RESPONSE TO REQUEST FOR ADDITIONAL INFORMATION

APR1400 Design Certification

Docket No. 52-046

RAI No.: 246-8307
SRP Section: 09.02.02 – Reactor Auxiliary Cooling Water Systems
Application Section: 9.2.8
Date of RAI Issue: 10/14/2015

Figure 9.2.8-1 Turbine Generator Building Closed Cooling Water System Flow Diagram (1 of 4)

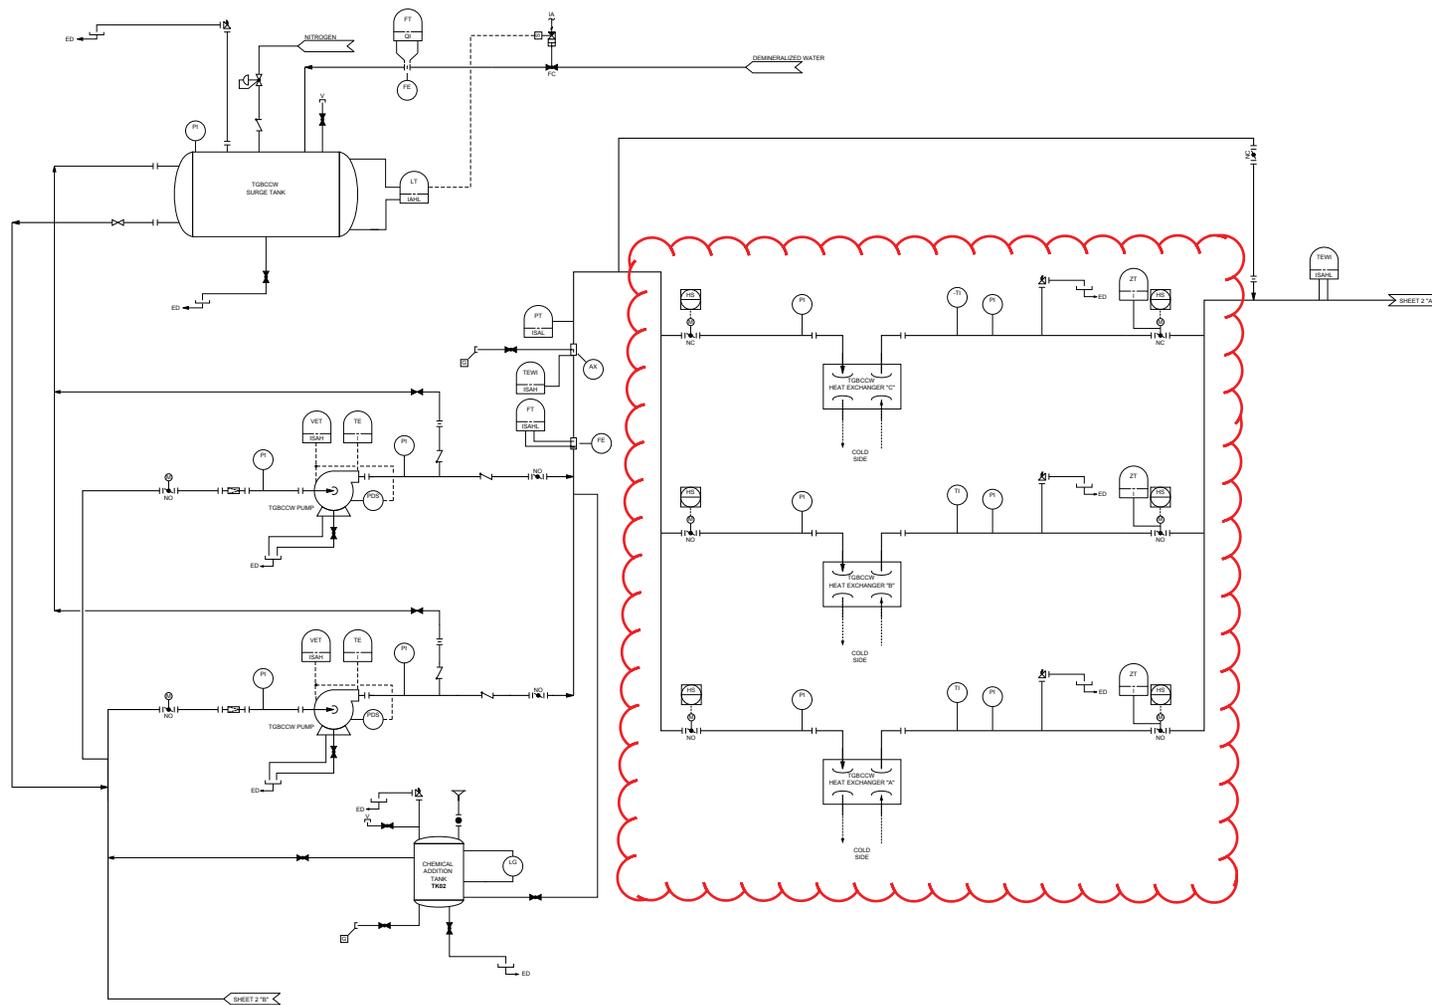
COL item 9.2(35) requires the COL applicant to maintain complete documentation of system design, construction, design modifications, field changes, and operations. The items addressed by this COL item, with the exception of the system design and design modifications, are post licensing actions that cannot be completed prior to the issuance of a COL license. Since the Turbine Building Closed Cooling Water (TBCCW) system is part of the design being certified, when referenced by a COL application, it will become part of the licensing basis for the COL. Design modification to the TBCCW in the COL application would likely be considered a departure and would be required to be identified as such in a COL application, and the NRC will review the change if required. Once a COL is issued, changes to the COL must be in accordance with 10CFR 52.98, "Finality of combined license; information requests," which provides information on what is required for changes to or departures from information within the scope of the reference design.

The applicant is requested to provide the basis for the COL item and to discuss why post licensing aspects such field changes and operations are included.

DCD Tier 2, OCL item 9.2(35) will be revised as indicated in the attachment to clarify what is required of the COL applicant.

KHNP also confirms that the TGBCCW is part of the design being certified, and that conceptual design information is presented in the DCD as follows:

- System design and operation description in DCD Subsection 9.2.8
- TGBCCW System component design parameters in Table 9.2.8-1, and
- TGBCCW flow diagrams in DCD Figure 9.2.8-1

The COL applicant is to confirm that there are no departures and shall meet the interface requirements (i.e., cooling duties and temperature requirements, piping and control interfaces) as defined in the conceptual design.

DCD Tier 2, Subsection 9.2.8.2.1, 9.2.8.2.2, 9.2.8.2.3, 9.2.9.1, 9.2.9.2.1, 9.2.9.2.2, 9.2.9.2.3, 9.2.10, 12.4.3, Table 1.8-2 (14 of 29 and 21 of 29), Table 9.2.8-1, Figure 9.2.8-1(1 of 4), and Figure 9.2.9-1 will be revised as indicated in the Attachment.
